## Addendum #2

### Port of Port Arthur Seafarer Center Parking Lot Expansion

Addendum Date:5-7-2024

401 HOUSTON AVE PORT ARTHUR, TX 77642 SEFARER PARKING LOT EXPANSION PROJECT	
	DATE:	5/6/24
	SCALE:	1/16" = 1'-0"
	SHEET:	ENLARGED STRIPING PLAN
	SHEET #:	8 OF 10

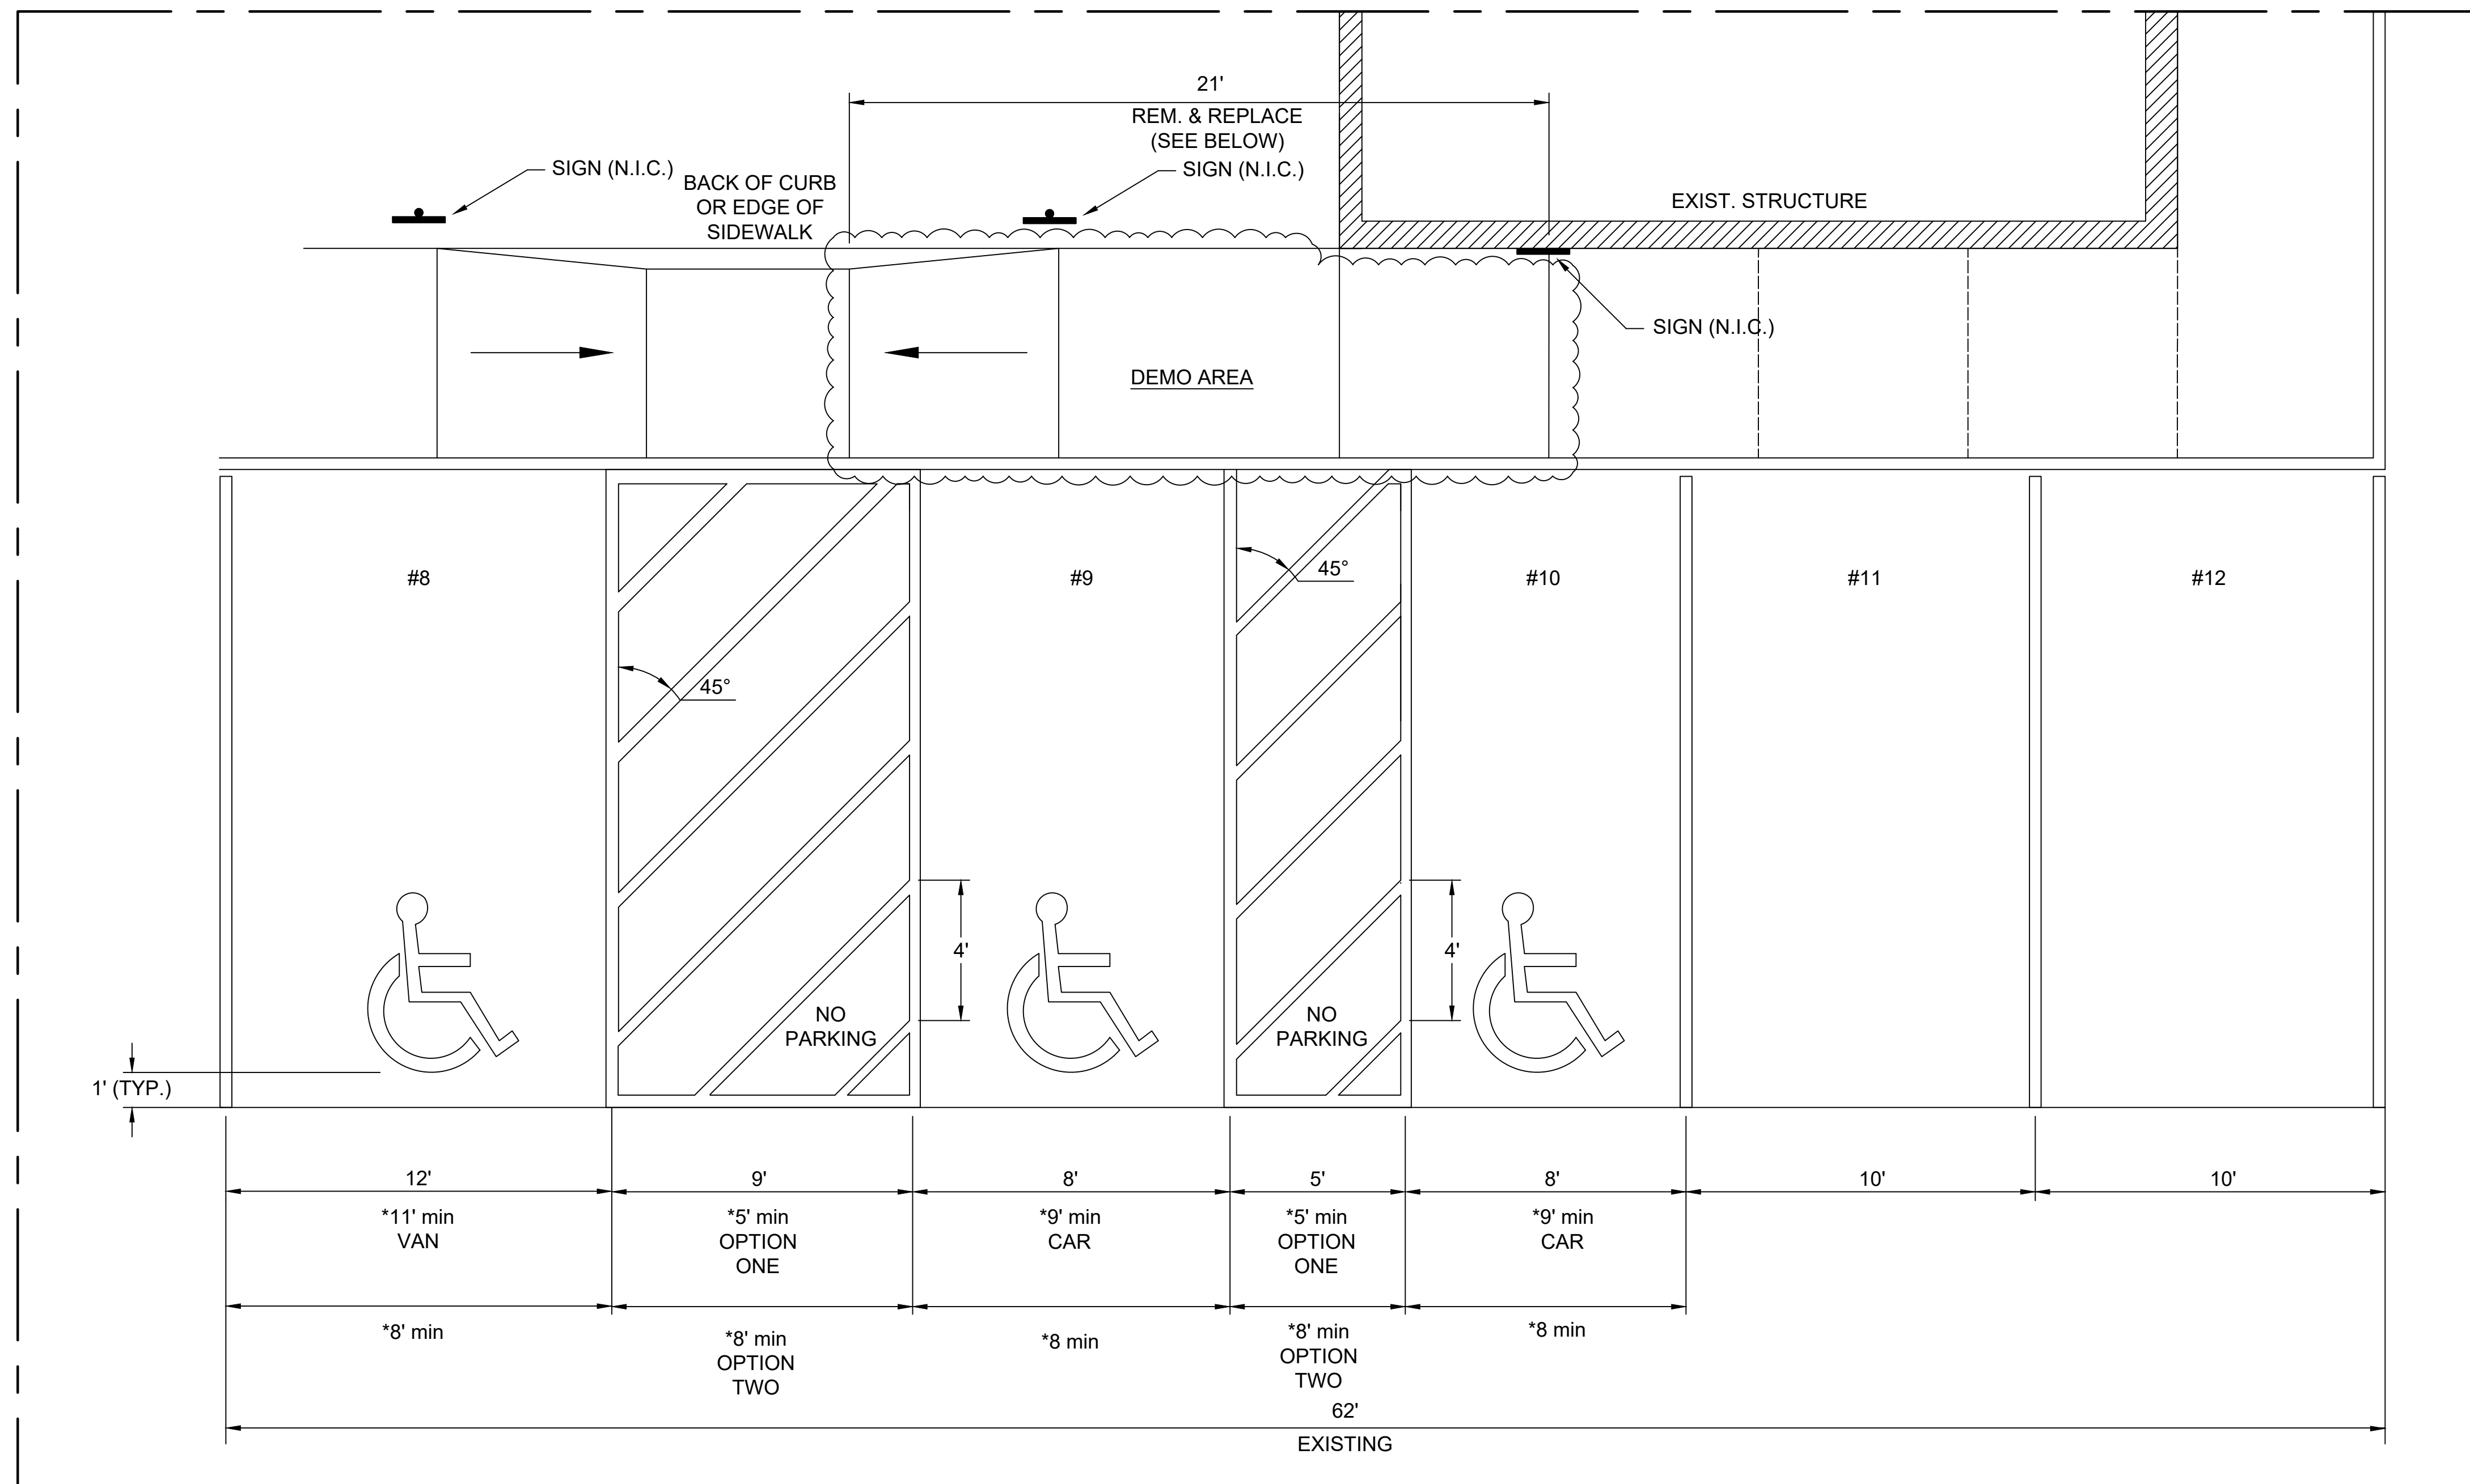
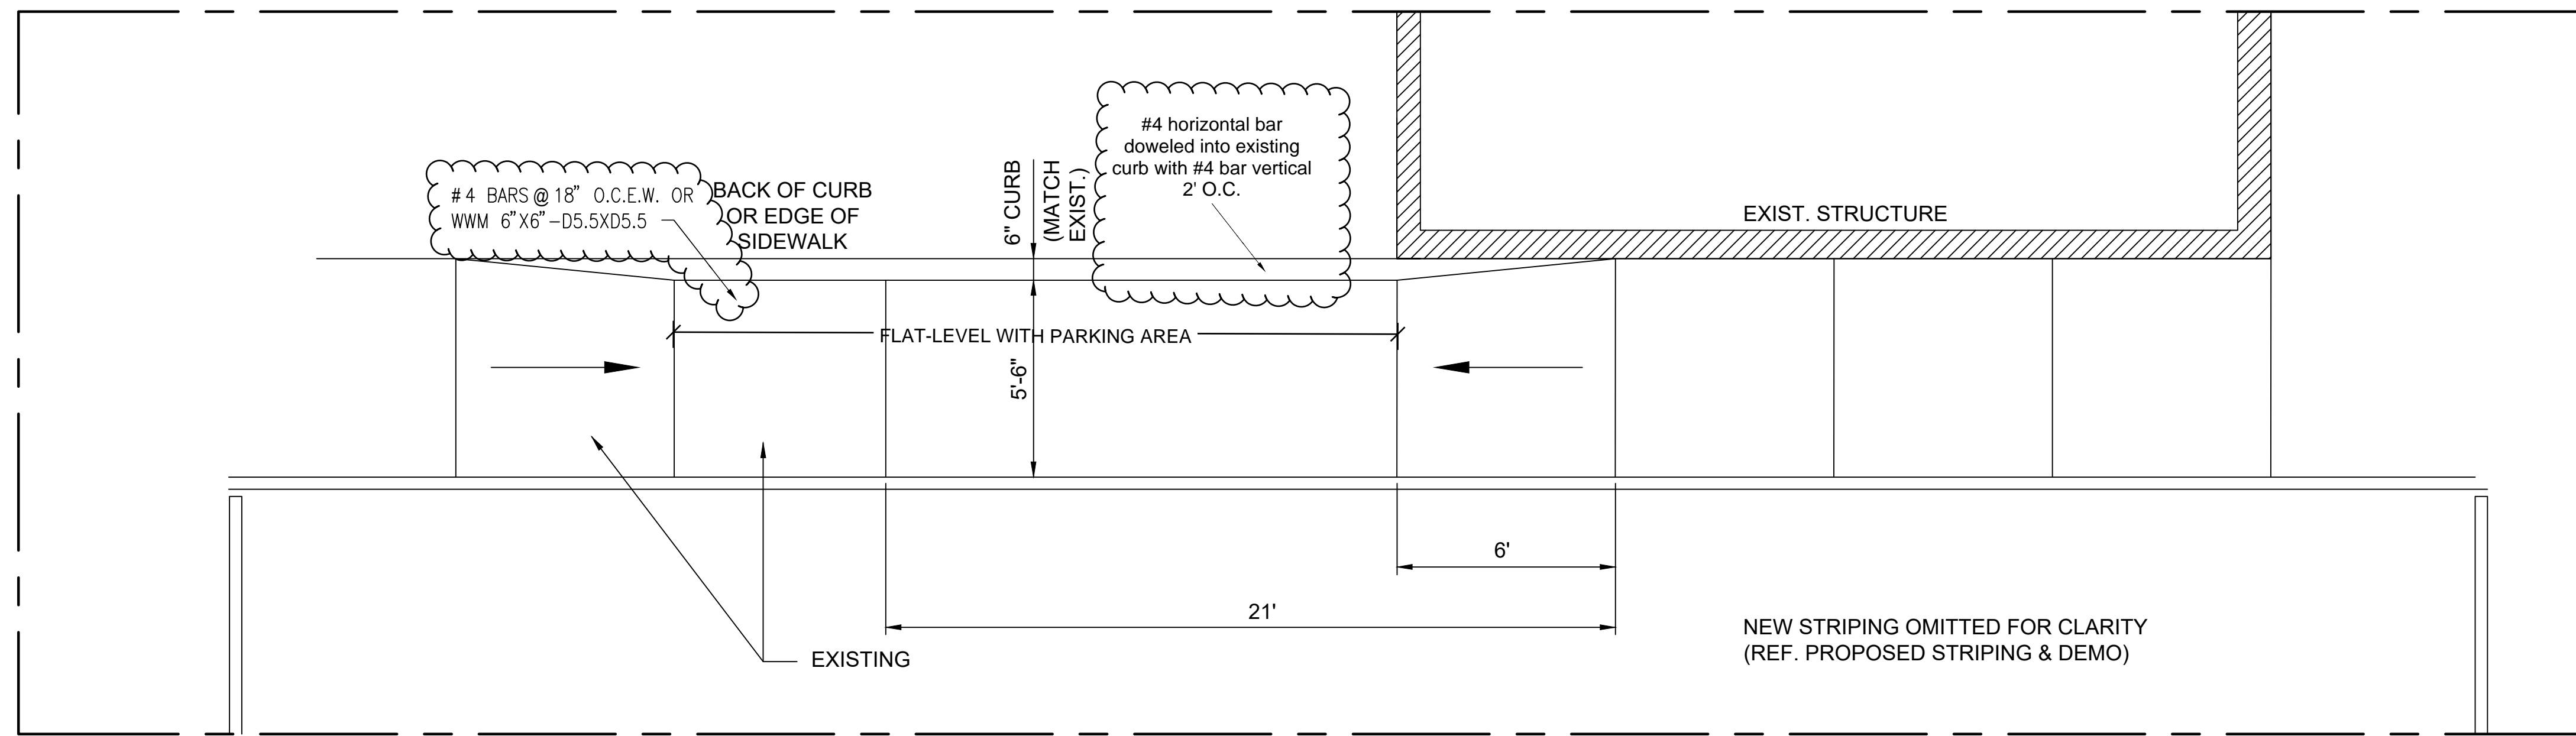
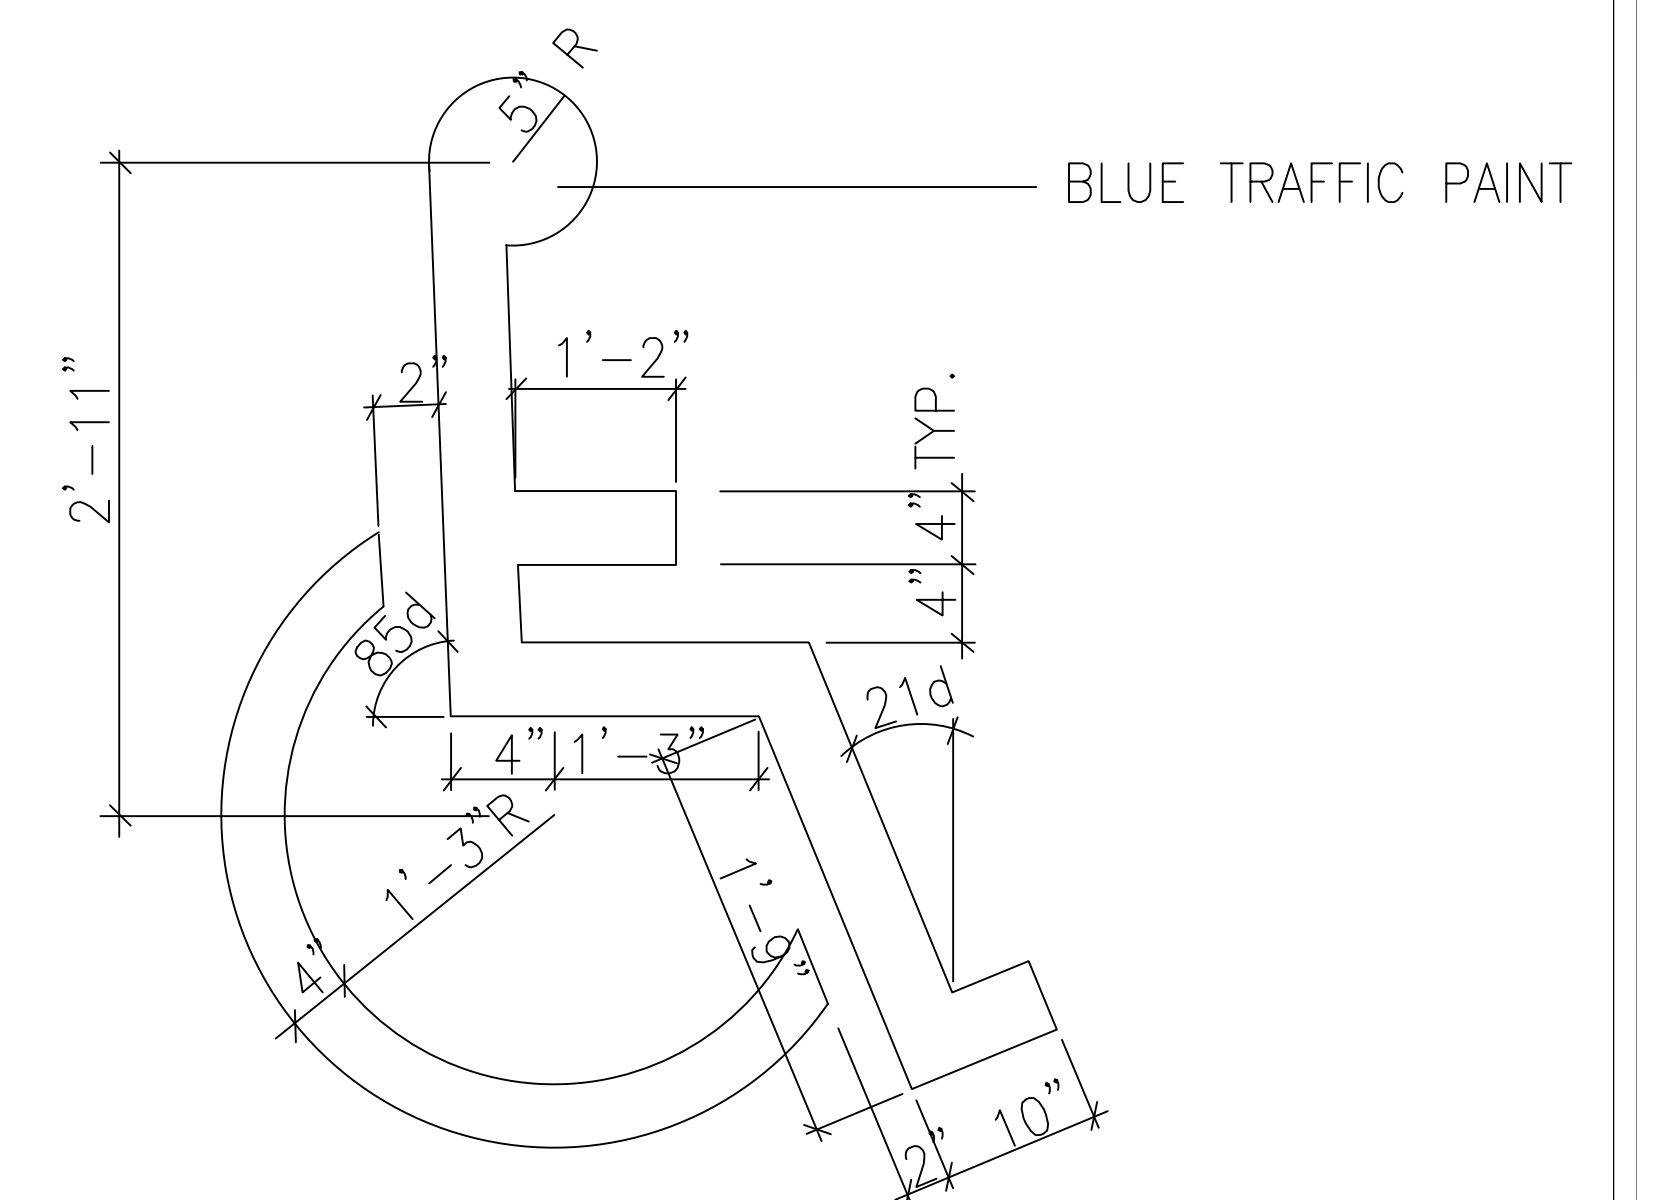
- *“On the signs as shown on plan sheet 8, what does N.I.C. stand for? Is one sign to be installed on the building and the other two in bollards per the middle detail on the right side of plan sheet 10?”*
  - Answer: N.I.C. means “Not In Contract”, and therefore contractor is not responsible for supplying or mounting of any ADA signage.

- *“Bid item 5, can you please clarify the scope of work to be included in this item?”*
  - Answer: Existing sidewalk is to be demolished for installation of ramp layout and also to allow for (1) new ADA parking space. See revised sheet #8 for additional detail / clarification.
